CITY OF WEST LAKE HILLS, TEXAS
NOTICE OF CITY COUNCIL REGULAR MEETING
Wednesday, October 28, 2020 at 7:00 PM

Doucet & Associates, Inc. (Doucet), is pleased to submit this response letter to our September 29, 2020 engineering drainage report documenting the analysis of a partial easement release located at 2 Downie Place in West Lake Hills, Texas. Our response to Comments 3-8 are as follows in blue text.

Cross Section 1

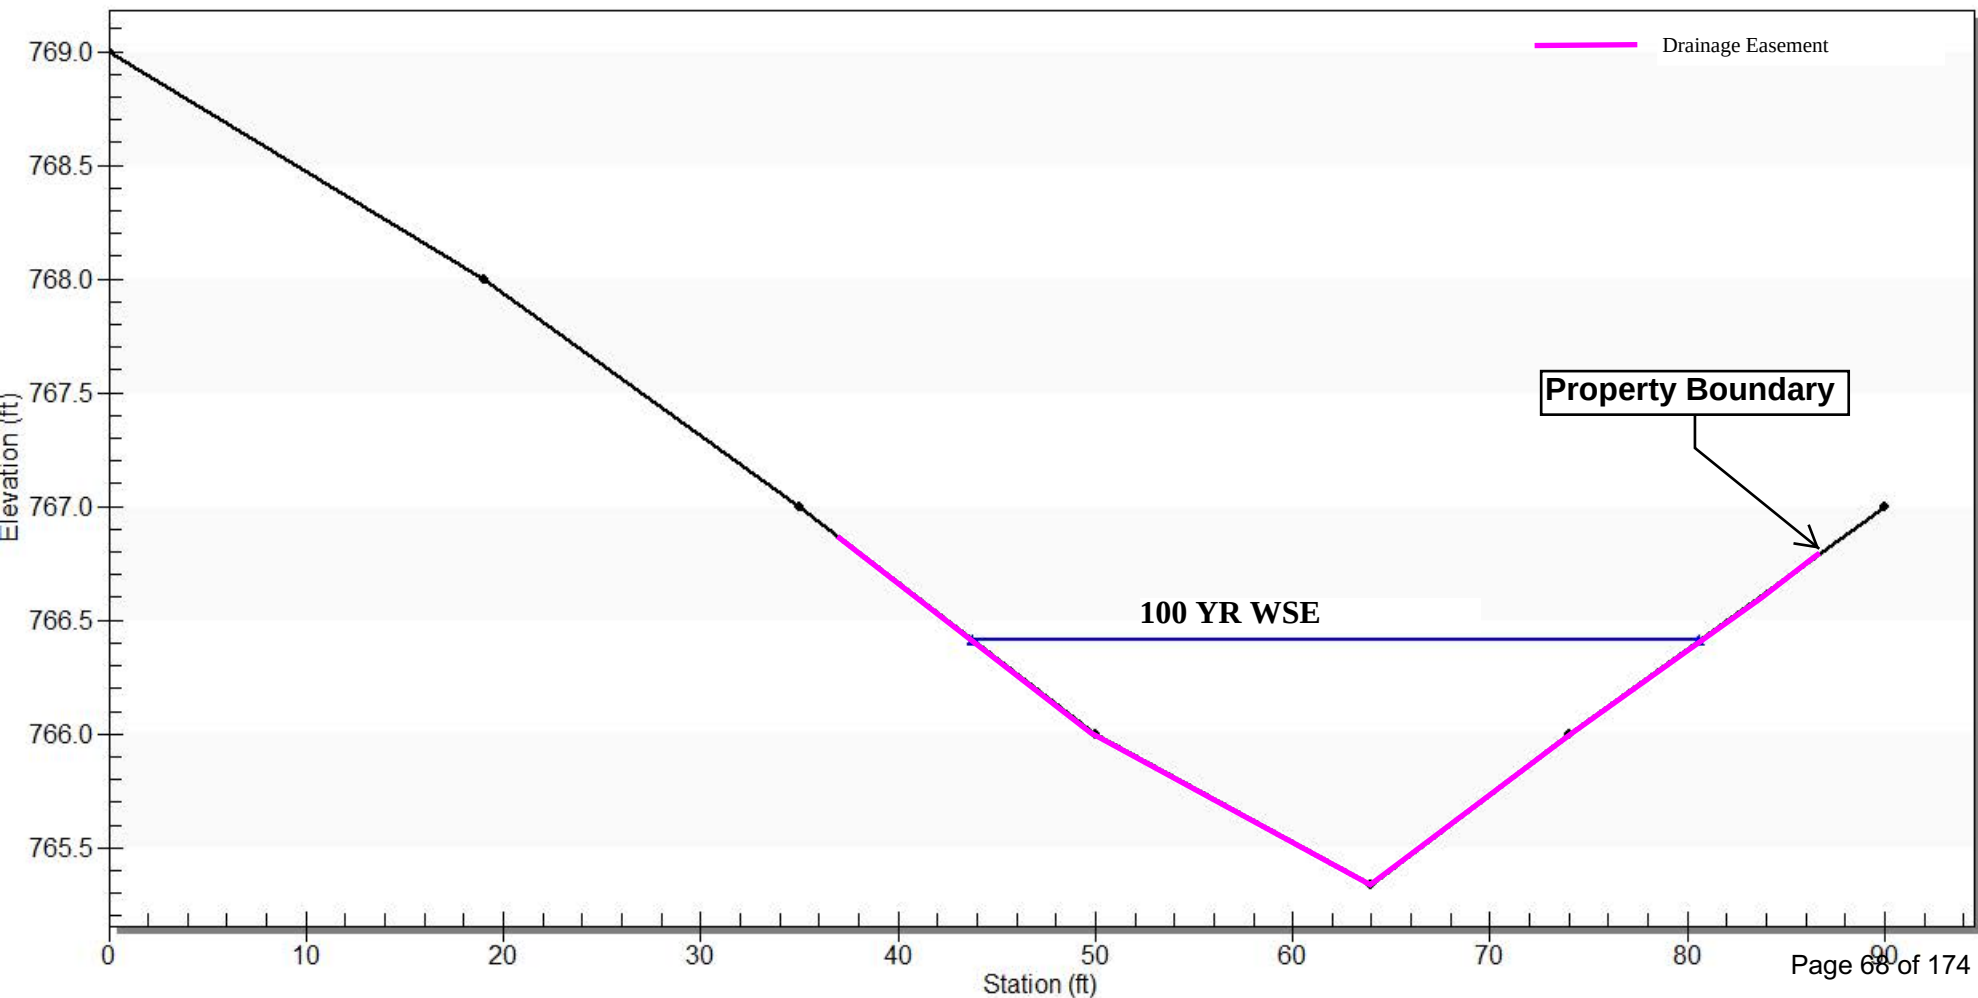
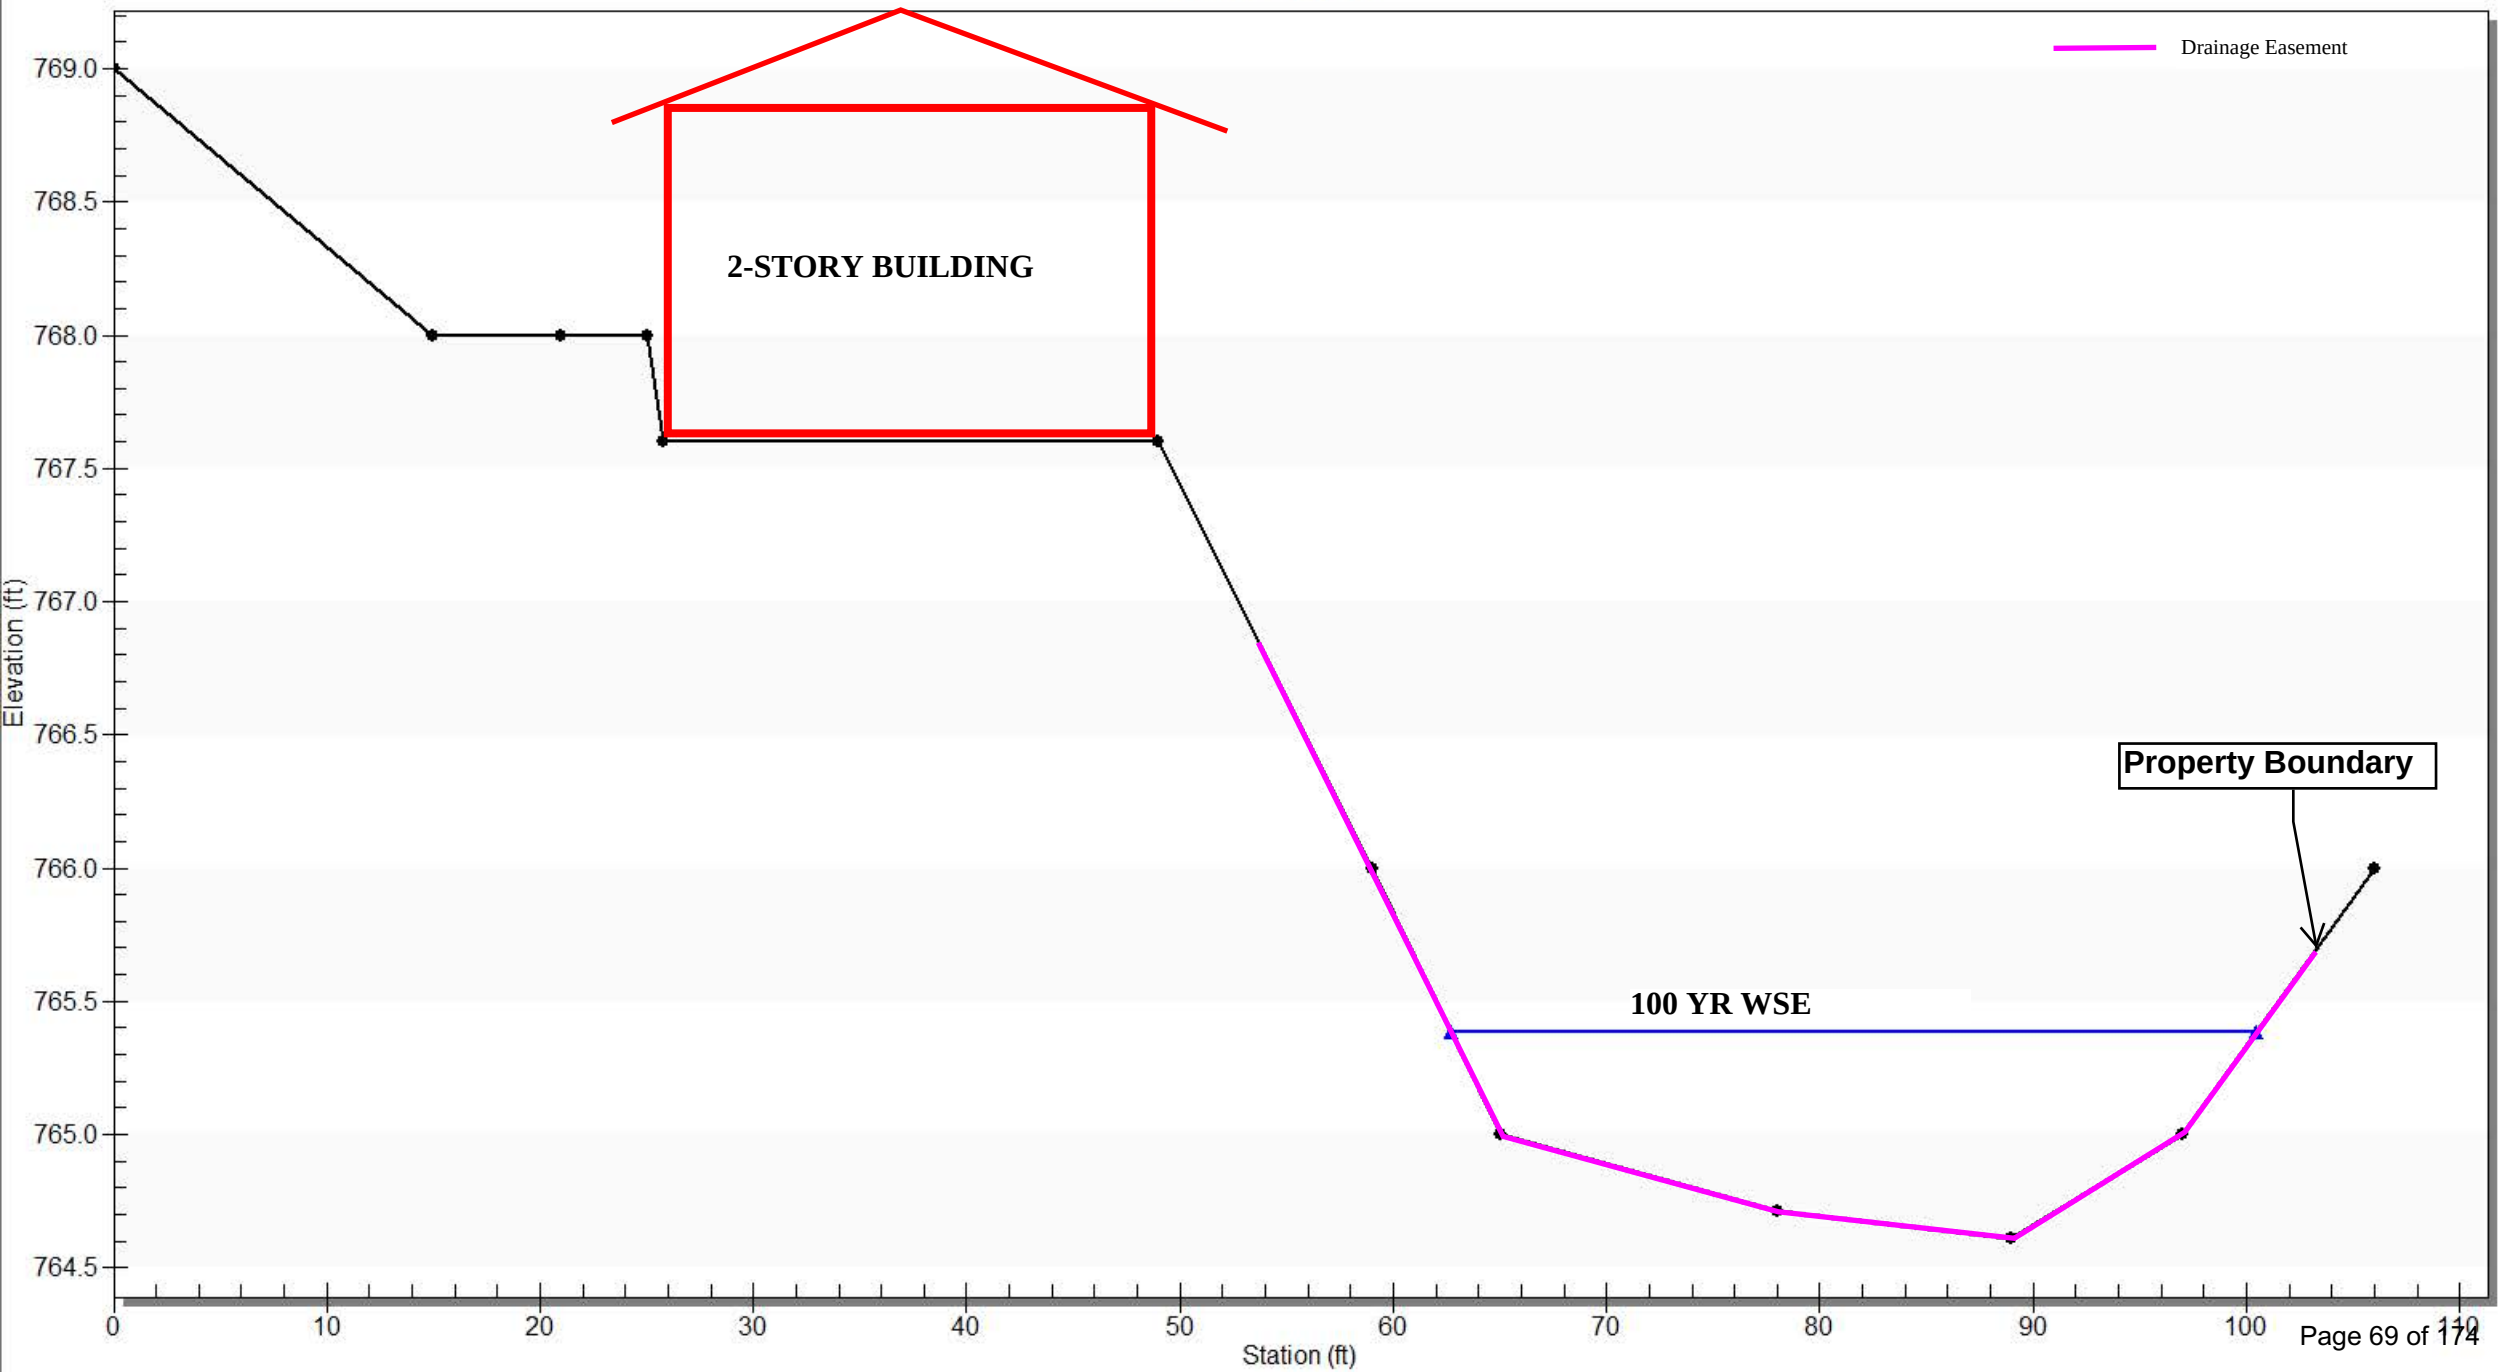
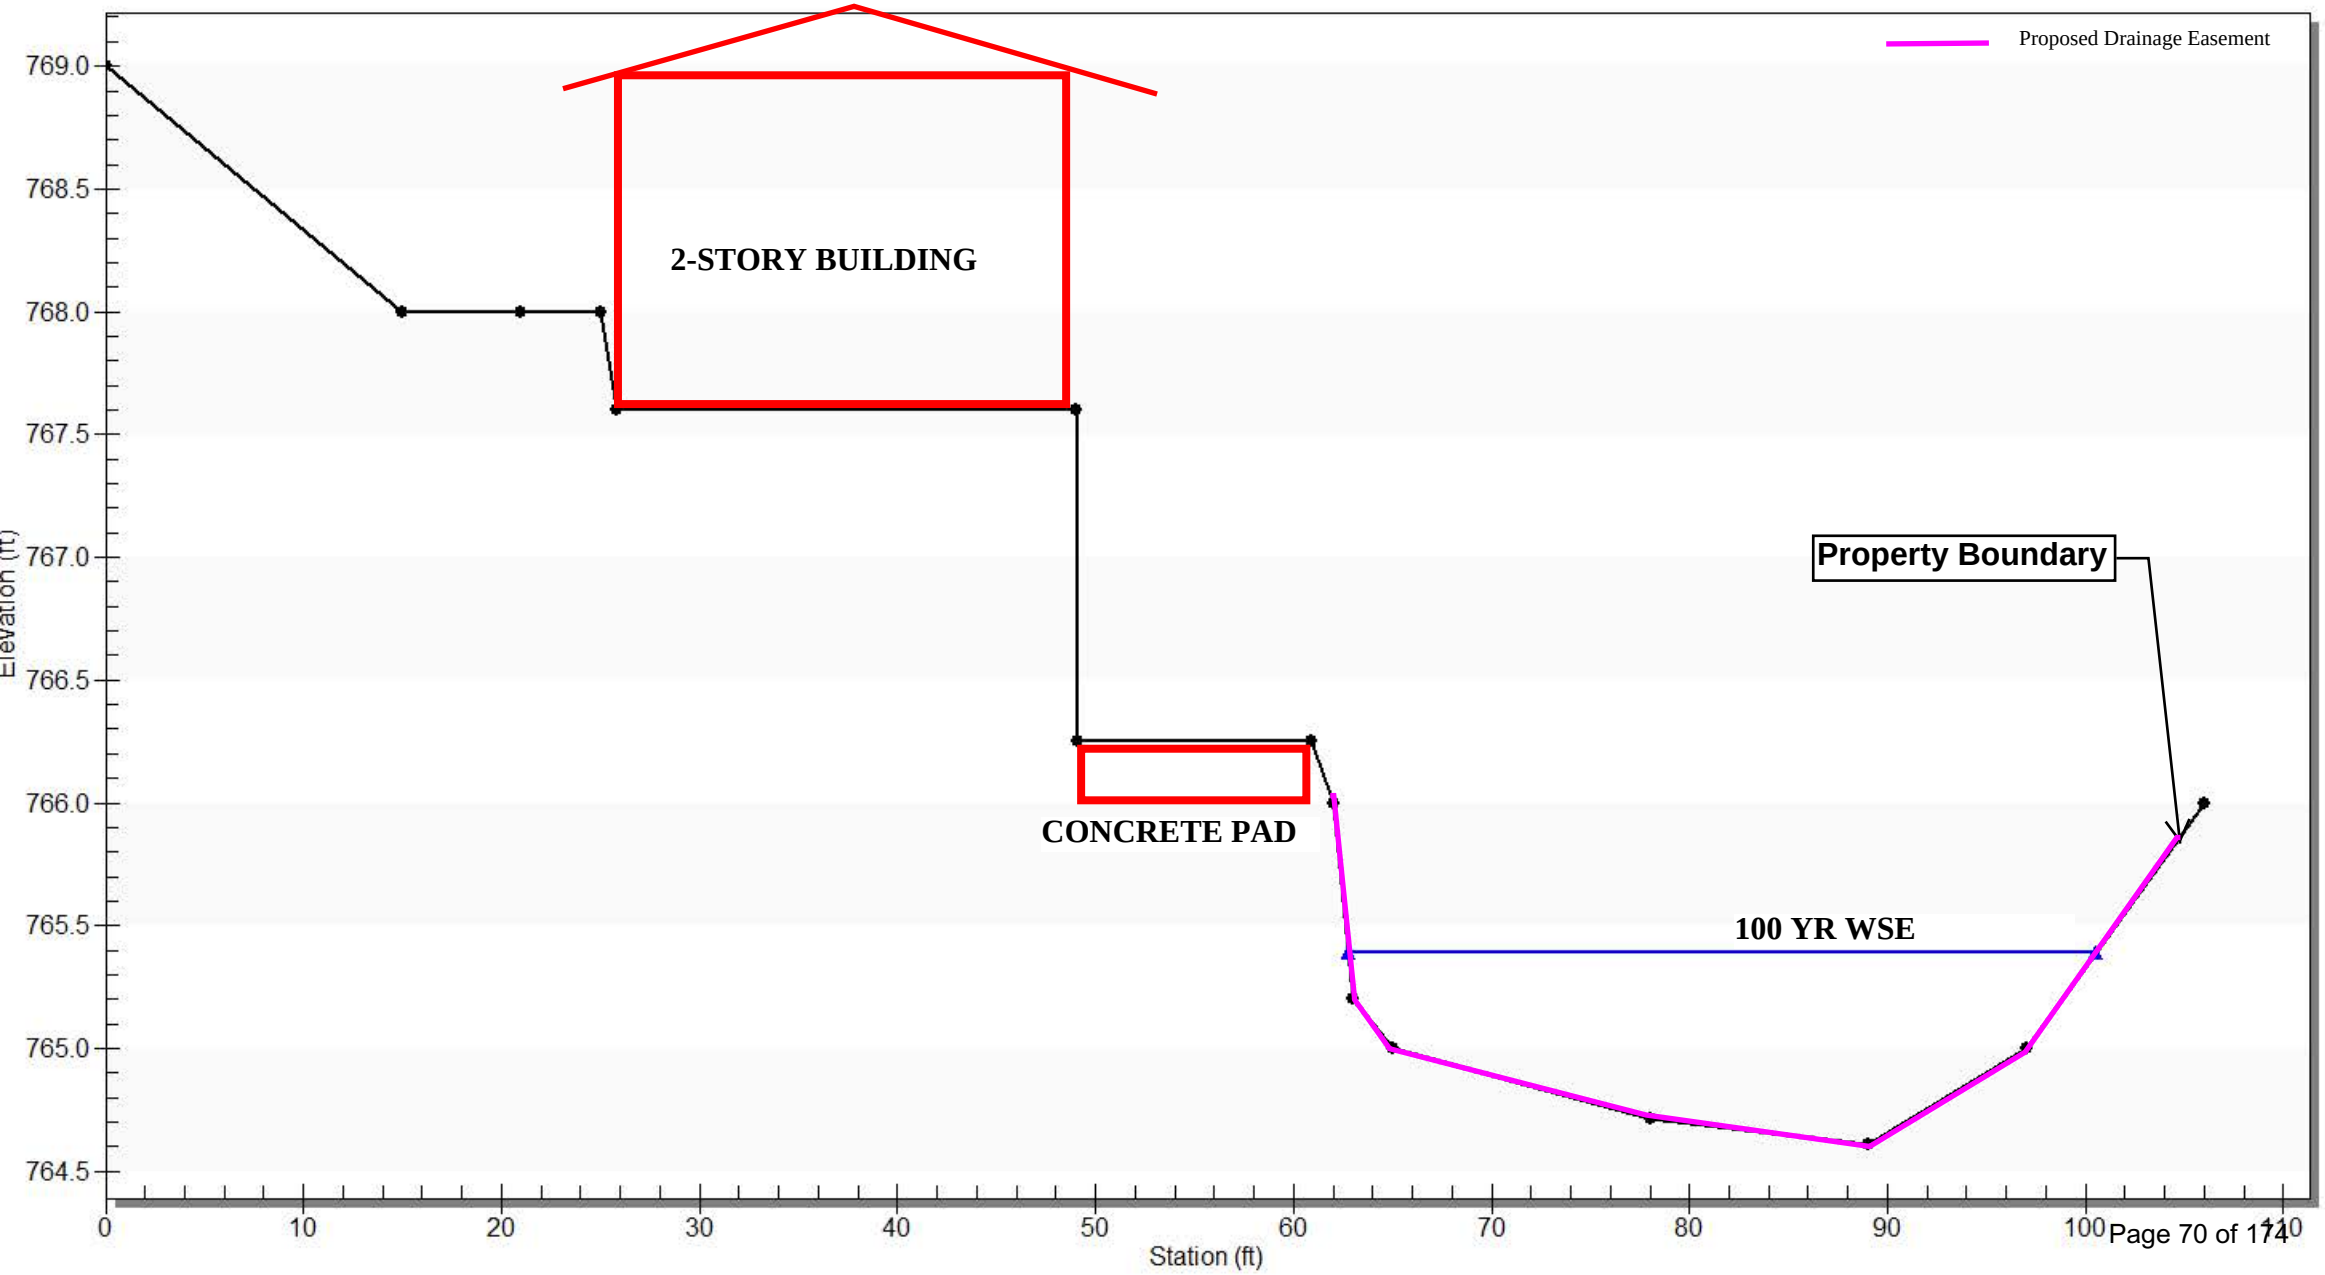
3. Please verify Easement overtopping elevations as they appear to be inconsistent with the survey provided.

3-C1) Please show property line, existing, and proposed easement line in the cross section to verify overtopping elevations.

7-C1) Please show property line, existing easement line, and proposed easement line in the cross sections.

Response: Easement lines and property boundary has been added to cross sections.

Response: Easement lines and property boundary has been added to cross sections.
